UNITED STATES
NUCLEAR REGULATORY COMMISSION
WASHINGTON, D. C. 20555

SUBJECT: ISSUANCE OF AMENDMENTS (TAC NOS. M83068 AND M83069) (TS 92-01)

AMENDMENT NO.167 FOR SEQUOYAH UNIT NO. 1 - DOCKET NO. 50-327 and
AMENDMENT NO.157 FOR SEQUOYAH UNIT NO. 2 - DOCKET NO. 50-328
DATED: April 28, 1993

SEQUOYAH NUCLEAR PLANT, UNIT 1

FIGURE 3.9-1 RELATIONSHIP BETWEEN LOAD, ALLOWABLE HEIGHT AND IMPACT AREA FOR OBJECTS TO BE CARRIED OVER THE IMPACT SHIELD

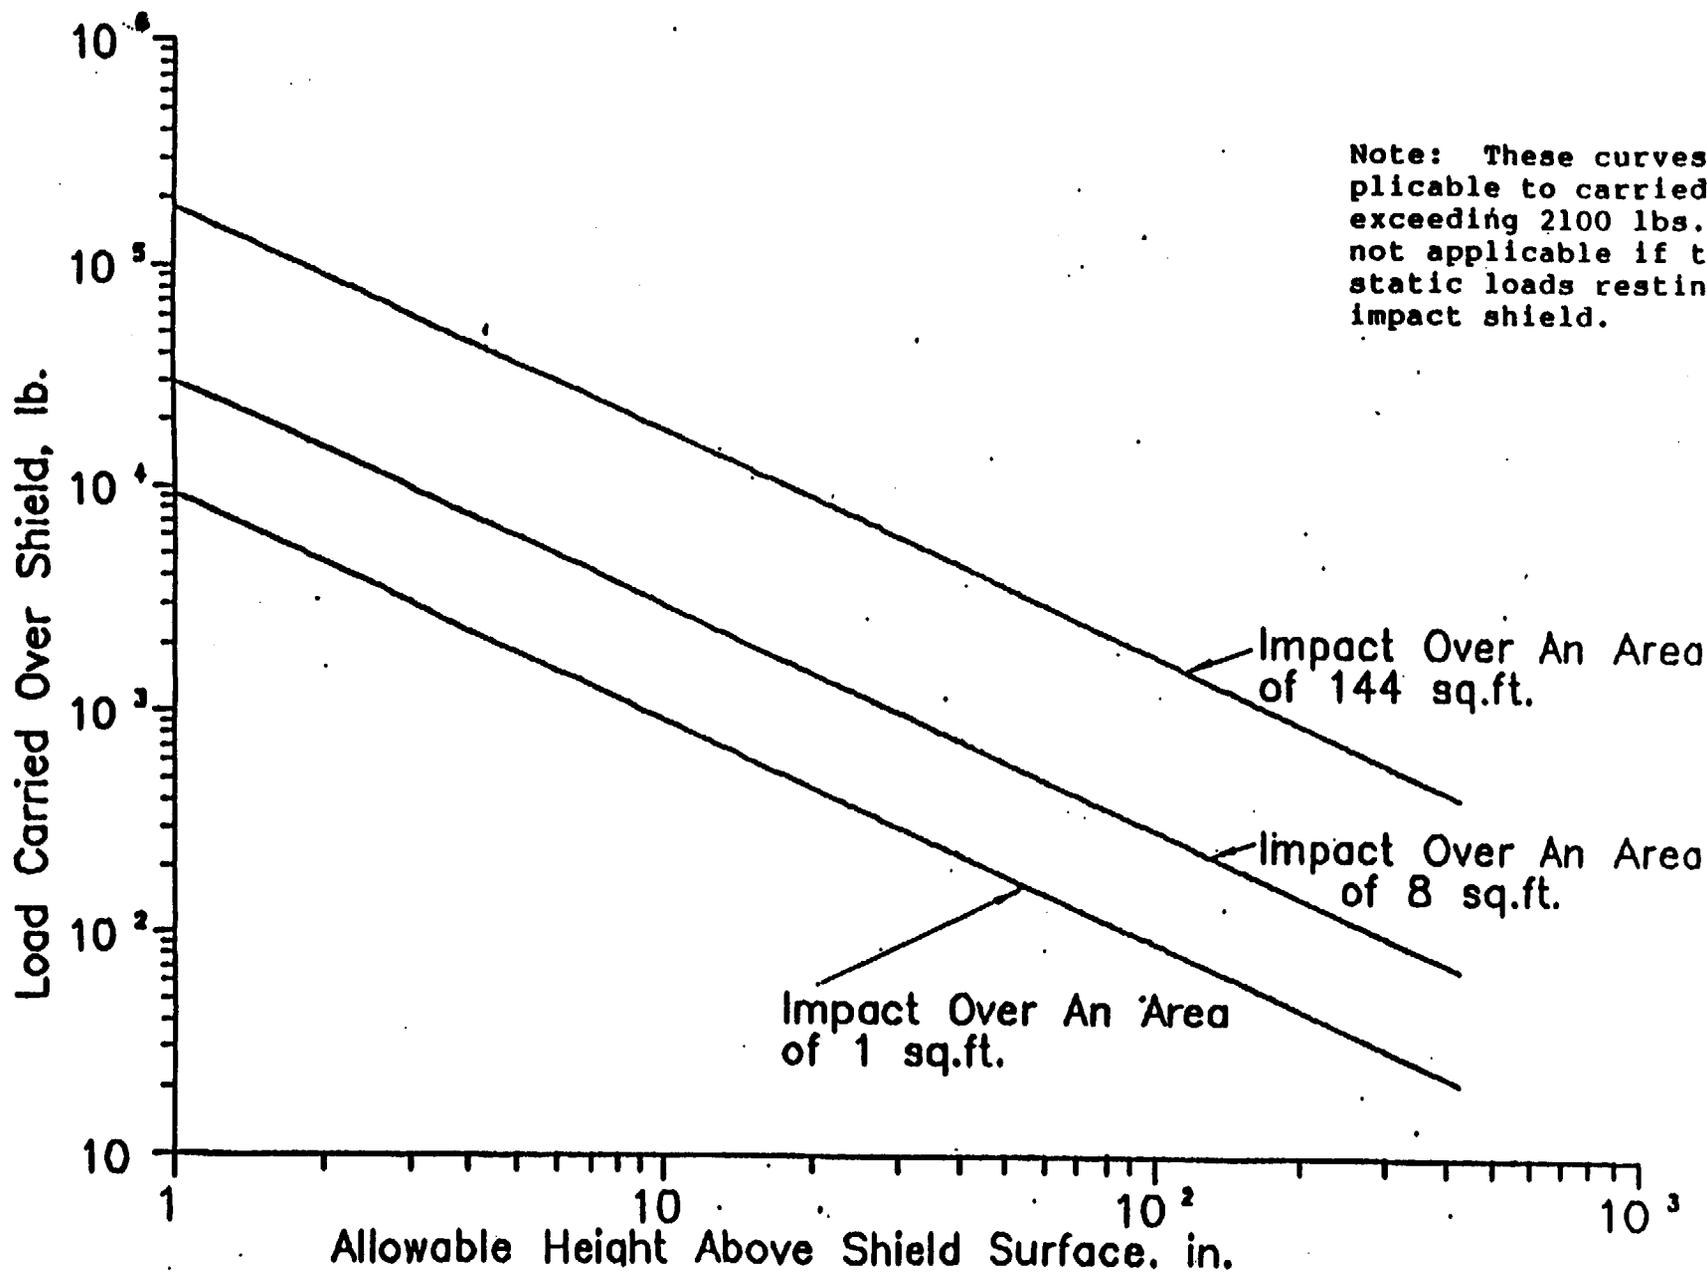
1. Loads which meet the weight, cross-sectional impact area, and allowable travel height criteria of Figure 3.9-1 may be carried over fuel assemblies stored in the cask loading area of the cask pit if the impact shield is in place over the cask loading area.
2. Loads which do not meet the weight, cross-sectional impact area, and allowable travel height criteria of Figure 3.9-1 shall be prohibited from travel over the cask loading area of the cask pit when fuel is stored in it.

4.9.7.2 When fuel is stored in the cask pit area, verify administrative requirements concerning the impact shield are met prior to moving loads in excess of 2100 pounds across the cask pit area.

Note: These curves are applicable to carried loads exceeding 2100 lbs. and are not applicable if there are static loads resting on the impact shield.

REFERENCE SPENT FUEL POOL LAYOUT

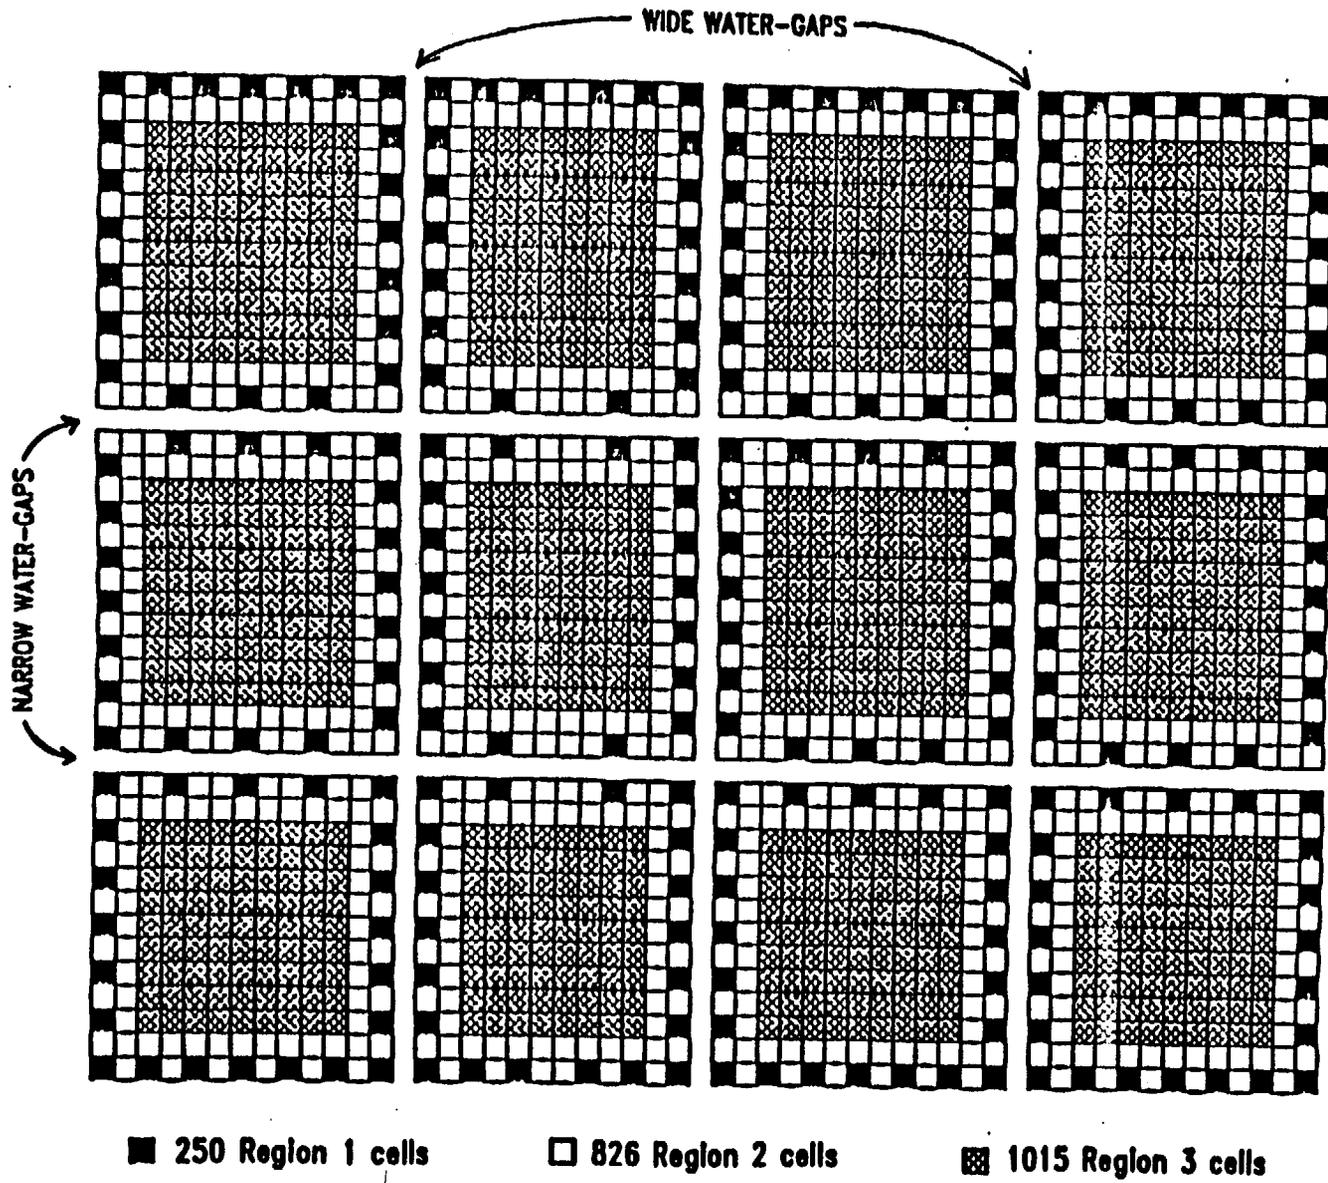
- d. The following arrangement of regions apply in the spent fuel storage pool:
 1. Region 1 fuel assemblies located along the periphery of the storage modules adjacent to the pool walls must be isolated from

Figure 5.6-1 shows a typical arrangement of regions. Figure 5.6-2 illustrates internal module checkerboarding of fresh fuel with empty cells in a portion of the fuel pool. Figure 5.6-3 illustrates the two burnup-enrichment equations (5.6.1.1.c.2 and 5.6.1.1.c.3) in graphical form.

FIGURE 5.6-2 EXAMPLE OF CHECKERBOARD SPENT FUEL STORAGE ARRAY

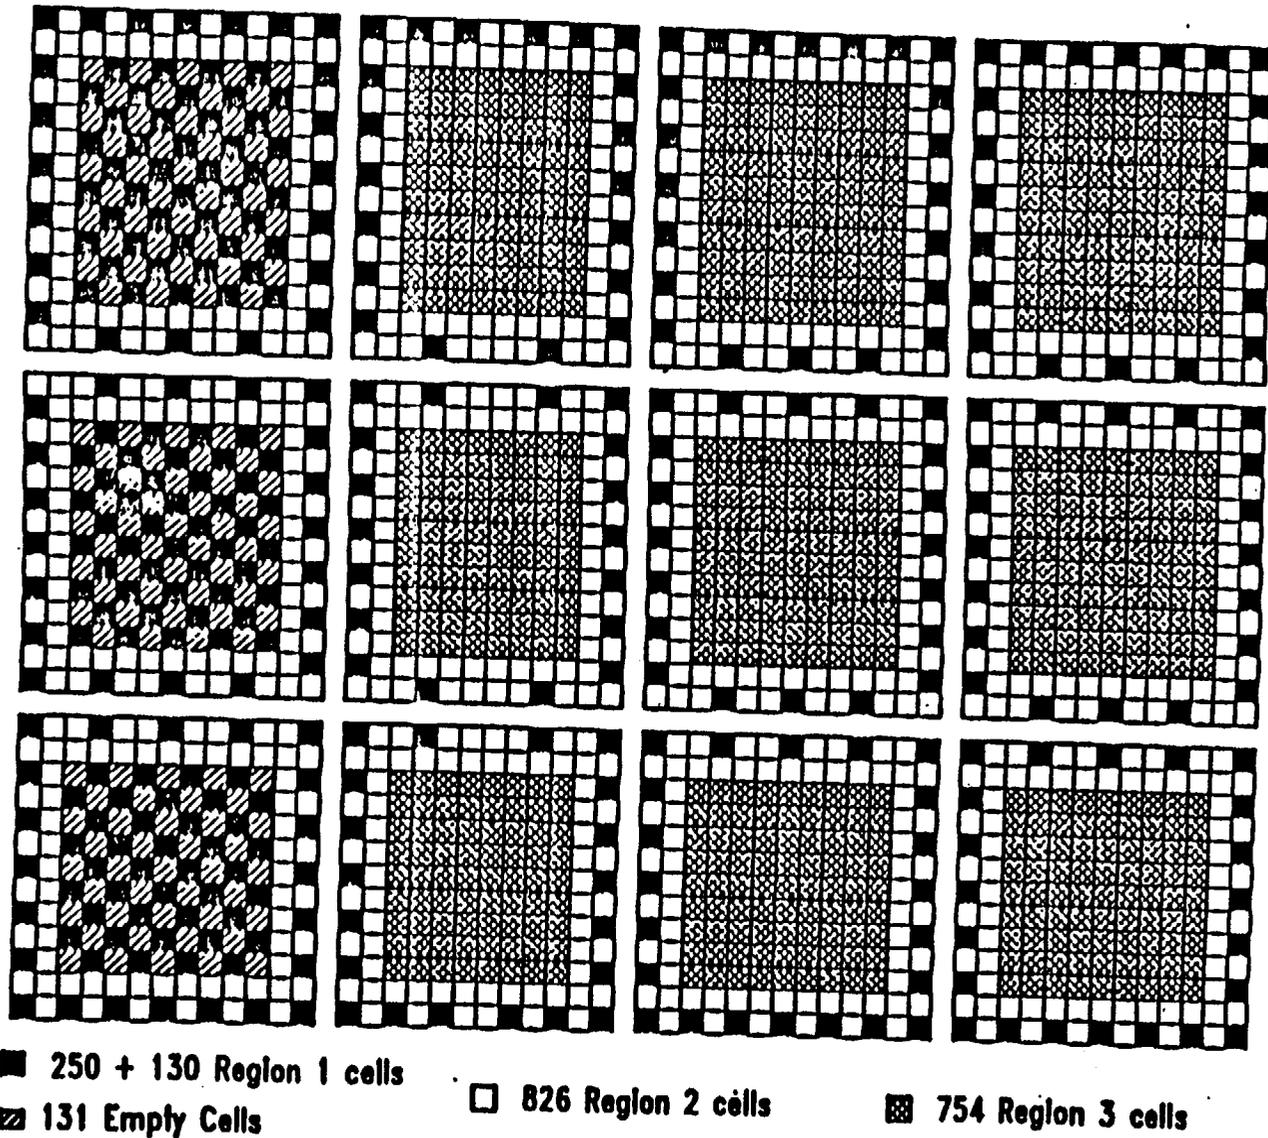
2. Region 1 fuel assemblies located along the wide water-gaps** between storage modules must be isolated from each other and from the inner Region 3 cells by at least one (1) Region 2 spent fuel assembly (i.e., fuel of 50 MWD/KgU assembly average burnup or equivalent).
3. Region 1 fuel assemblies located along the narrow water-gaps** between storage modules must be isolated from each other by at least two (2) Region 2 spent fuel assemblies and from the inner Region 3 cells by at least one (1) Region 2 spent fuel assembly (i.e., fuel of 50 MWD/KgU assembly average burnup or equivalent).
4. A checkerboard pattern of fresh fuel and empty cells may be used throughout any storage module, or internal to any storage module in lieu of Region 3 fuel as shown in Figure 5.6-2.

FIGURE 5.6-3

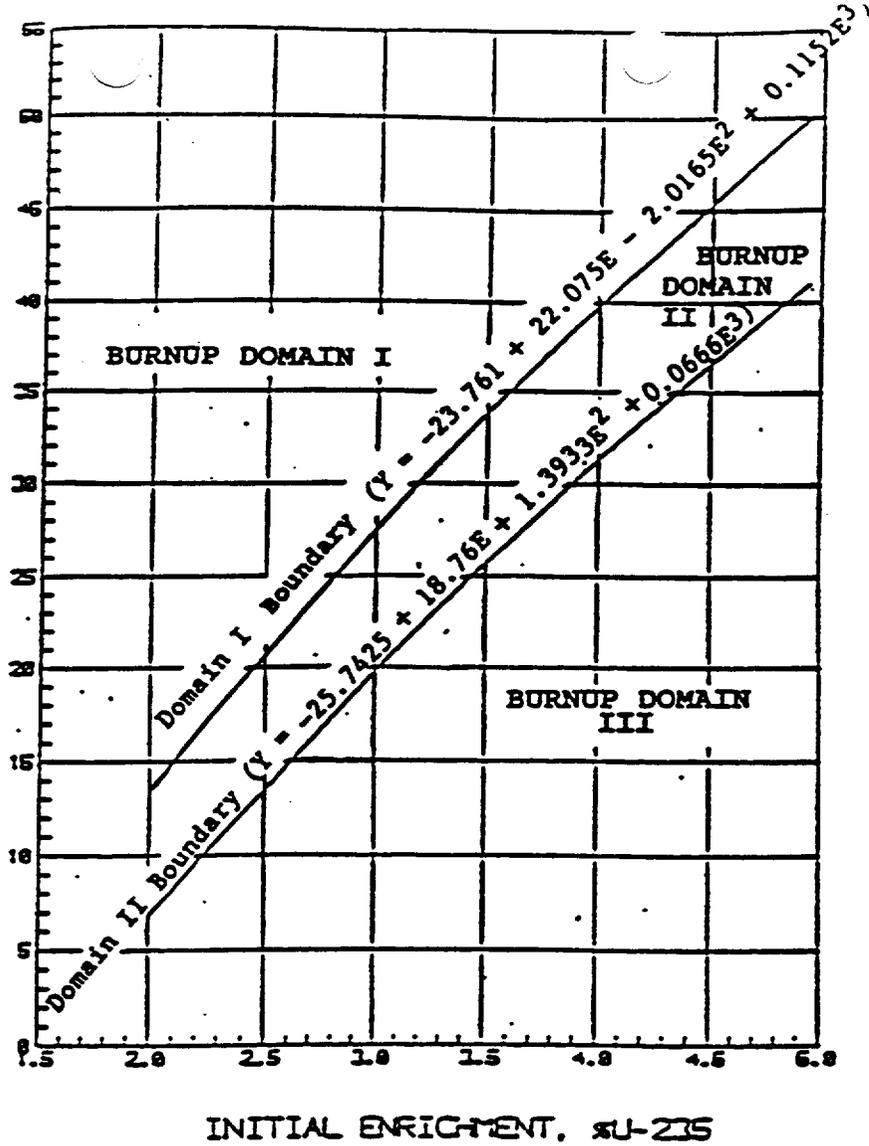
- Domain I:** Fuel assemblies with initial enrichment-burnup combinations in Domain I may be placed in either Region 1, 2, or 3 storage cells.
- Domain II:** Fuel assemblies with initial enrichment-burnup combinations in Domain II shall be placed only in Region 1 or 3 storage cells.
- Domain III:** Fuel assemblies with initial enrichment-burnup combinations in Domain III shall be placed only in Region 1 storage cells.

FIGURE 3.9-1 RELATIONSHIP BETWEEN LOAD, ALLOWABLE HEIGHT AND IMPACT AREA FOR OBJECTS TO BE CARRIED OVER THE IMPACT SHIELD

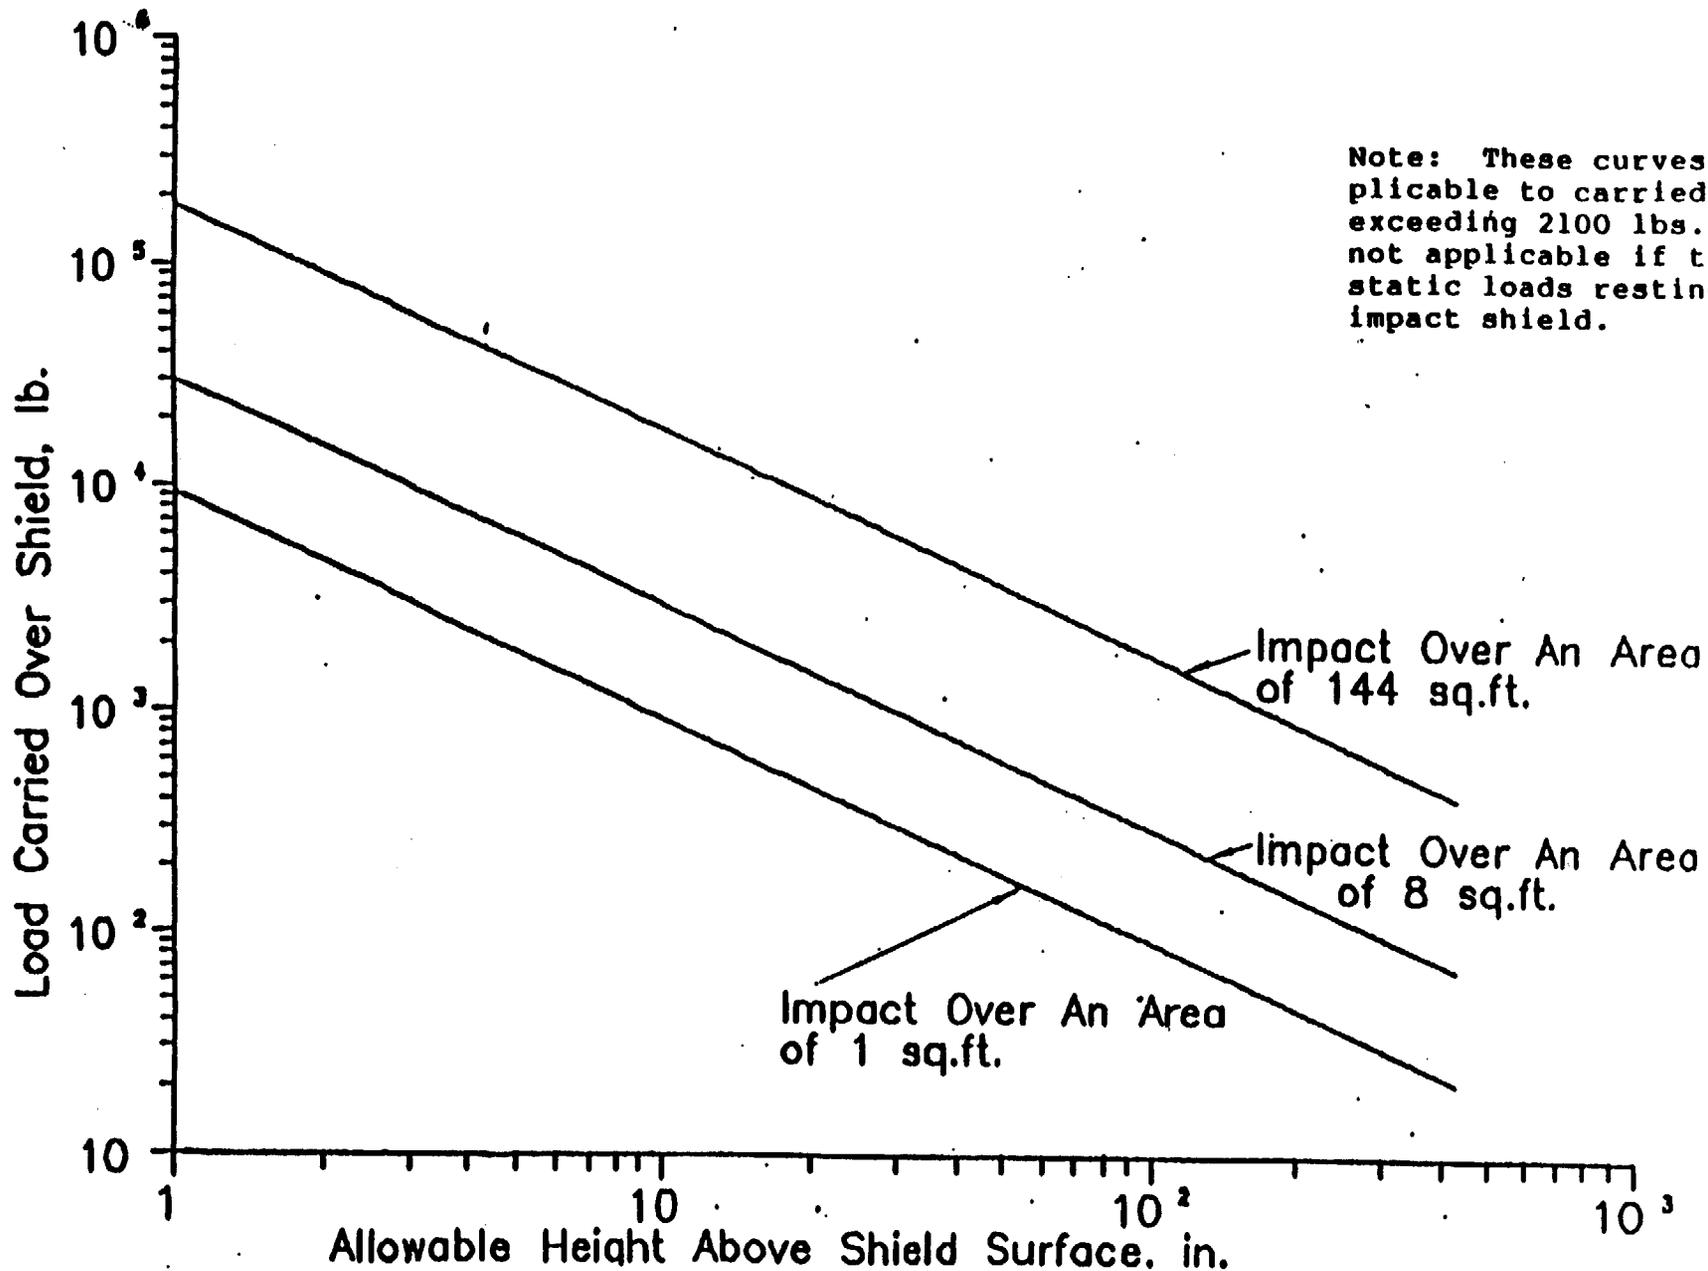
1. Loads which meet the weight, cross-sectional impact area, and allowable travel height criteria of Figure 3.9-1 may be carried over fuel assemblies stored in the cask loading area of the cask pit if the impact shield is in place over the cask loading area.

2. Loads which do not meet the weight, cross-sectional impact area, and allowable travel height criteria of Figure 3.9-1 shall be prohibited from travel over the cask loading area of the cask pit when fuel is stored in it.

The licensee also proposed changes to TS 3/4.9.7 requiring placement of an impact shield over fuel stored in the cask loading area, restricting the load, height and impact area of loads greater than 2100 pounds carried over the impact shield covering the cask pit, clarifying the surveillance requirement to demonstrate crane interlocks and physical stops are operable, and adding a surveillance requirement to verify that the administrative restrictions associated with the impact shield are met prior to carrying heavy loads over the cask pit area. These changes are consistent with the guidance of Regulatory Guide 1.13 and the requirements of GDCs 4, 61 and 62 with regard to protecting the stored fuel from the effects of accidental heavy load drops. Therefore, the proposed changes to TS 3/4.9.7 are acceptable.

FIGURE 5.6-1

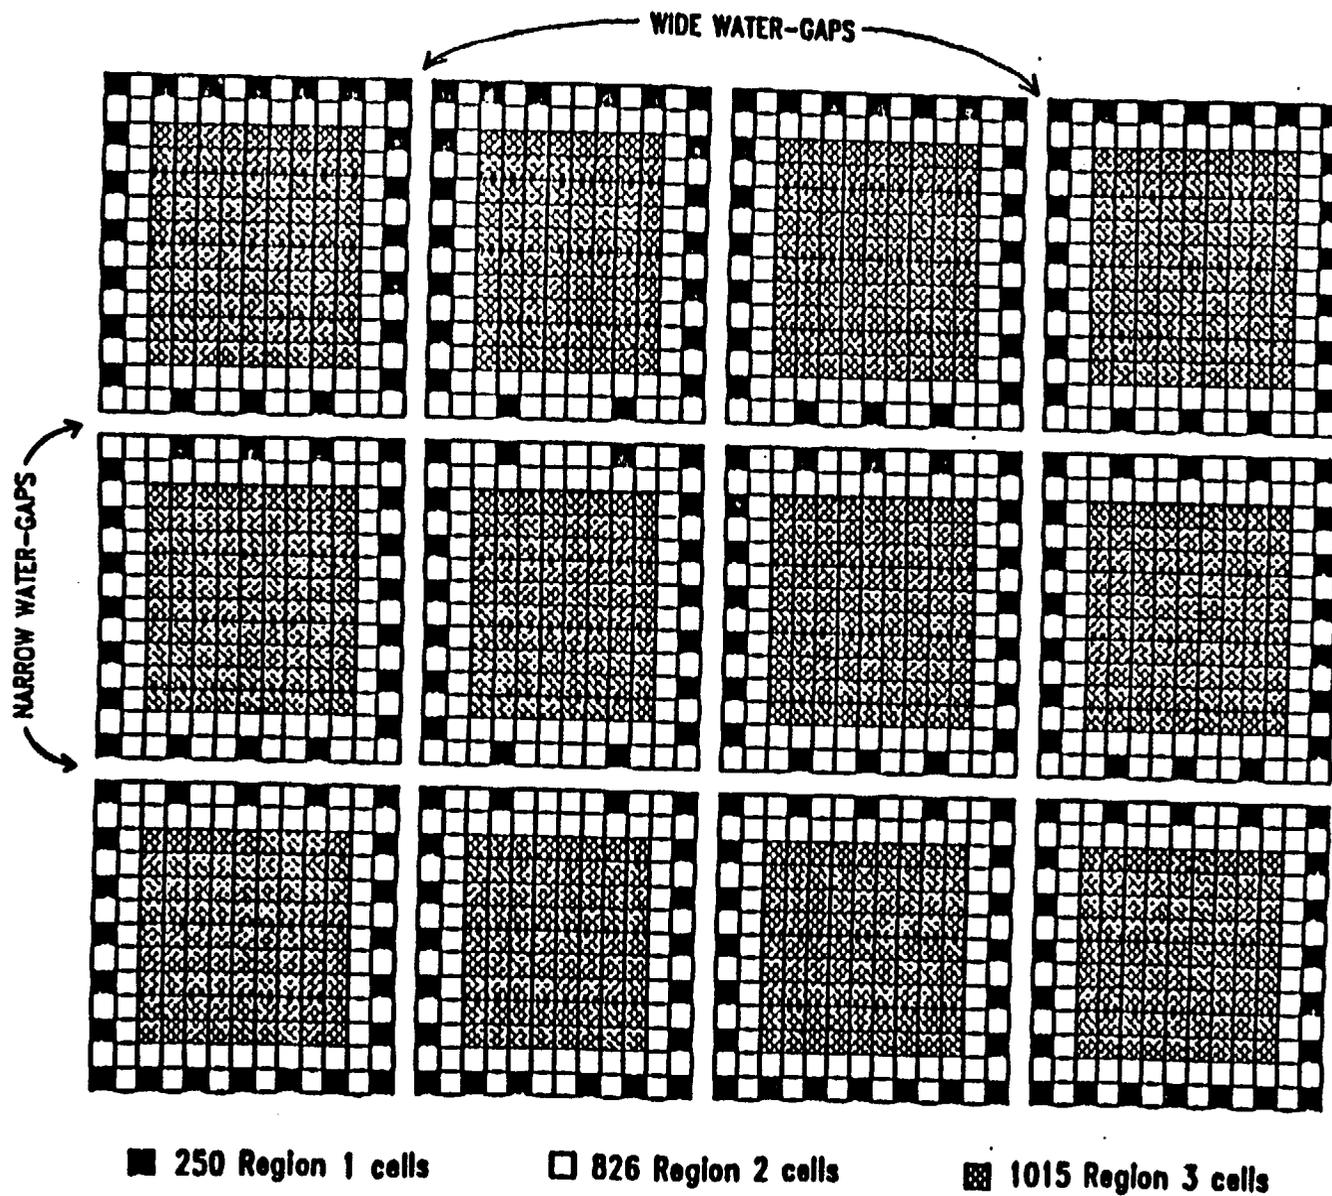
Figure 5.6-1 shows a typical arrangement of regions. Figure 5.6-2 illustrates internal module checkerboarding of fresh fuel with empty cells in a portion of the fuel pool. Figure 5.6-3 illustrates the two burnup-enrichment equations (5.6.1.1.c.2 and 5.6.1.1.c.3) in graphical form.

SFP with accompanying definitions and an explanation of where fuel assemblies would be stored according to initial fuel enrichment and burnup parameters. Figure 6.5-1 would be added to illustrate a typical arrangement of fuel regions. Figure 5.6-2 would be added to illustrate internal module checkerboarding of fresh fuel with empty cells. Figure 5.6-3 would be added to illustrate graphically the two fuel burnup versus enrichment equations.
